# PLANNING BOARD REPORT PORTLAND, MAINE

Three unit residential condominium building  
30 Fox Street  
Level III Subdivision and Site Plan  
#2017-227  
CBL: 012 J004001  
Dyer Neck Development LLC, Applicant

Submitted to Portland Planning Board  
Public Hearing Date: April 10<sup>th</sup>, 2018

Prepared by: Jean Fraser  
Date: April 6<sup>th</sup>, 2018

**PREVIOUS SITE LAYOUT:**

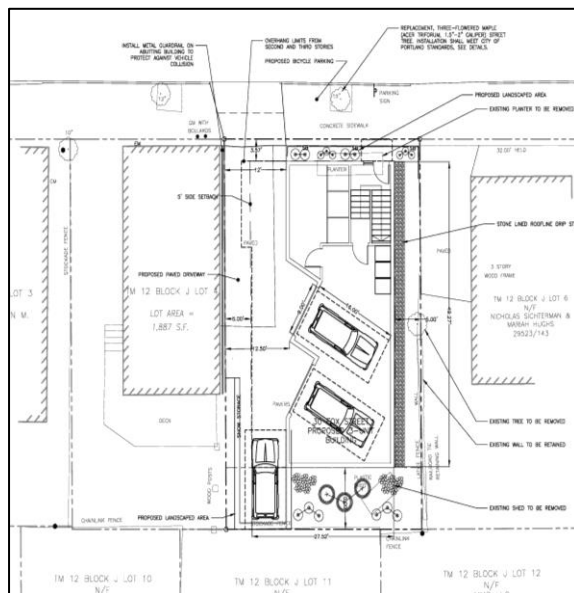
The proposal previously included three parking spaces (2 under the building and one at the end of the drive access, as shown right) and this layout would require parked vehicles to back out to leave the site:

At the Workshop staff comments confirmed that at this location the vehicles must exit the site going forward for safety reasons (Attachments 4 and 8). Neighbors and staff raised a concern over the 11-12 foot width of the parking aisle as originally proposed, when the Technical Standard for perpendicular parking is 24 feet for the parking aisle.

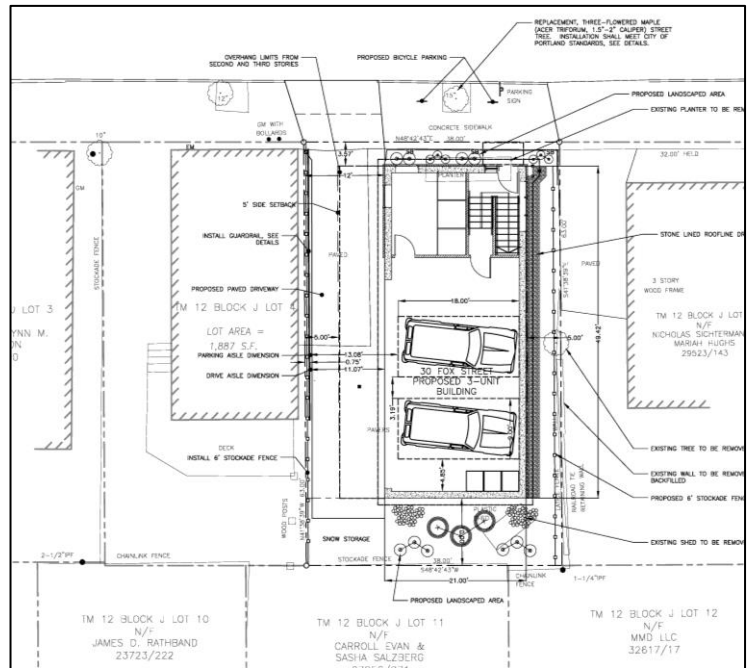
The final layout has been revised as noted below:

- To include full size parking spaces under the building as there is space;
- To reduce the number of parking spaces to two, both under the building;
- Remove the garage doors and supporting column between the doors to create an open parking and maneuvering area;
- Provide a turning area at the end of the drive access so that vehicles can exit going forward;
- The parking aisle has been increased to 13 feet, with a waiver requested in respect of the Technical Standard.

The development of this final proposal has involved extensive revisions based on field simulations (most observed by reviewers who also checked the dimensions as marked on the site - videos are attached at *Plan P17*) of vehicles maneuvering into and out of the parking space based on various parking area dimensions. Several earlier designs were not supported by the Traffic Engineering reviewer Mr Errico, but this final layout and the associated waiver is supported by Mr Errico (Attachment 8) as quoted below:

*As documented previously and repeated below, City staff does not support the backing of vehicles from the proposed site based upon conditions on Fox Street and the impact vehicle maneuvers may have on safety. I have observed several vehicle simulations conducted on the project site performed by the Applicant. These simulations included several access/egress movements using both a Nissan Rogue and a Toyota Highlander. The Applicant conducted additional simulations (provided via video) using a Jeep Cherokee and a Subaru Outback as design vehicles. These later simulation maneuvers assumed wider garage door openings due to a redesign of the building column between the two doors. Subsequent to these simulation tests, the Applicant has redesigned the building and removed the building column, thus eliminating a key factor limiting vehicle circulation. Given the results of the simulation tests and the elimination of the building column, it is my professional opinion that vehicles will be able to perform appropriate maneuvers for head-out egress movements. Accordingly, I support a waiver from the City's Technical Standards for parking aisle width with the following conditions.*

- *The area in the rear of the site noted for snow storage shall be paved and be available for vehicle maneuvering. It is likely that vehicles will pull into this area and back into the garage opening, setting up a head-out egress movement.*
- *A maximum of two vehicles shall be permitted on the site.*
- *Backing maneuvers onto Fox Street shall be prohibited.*
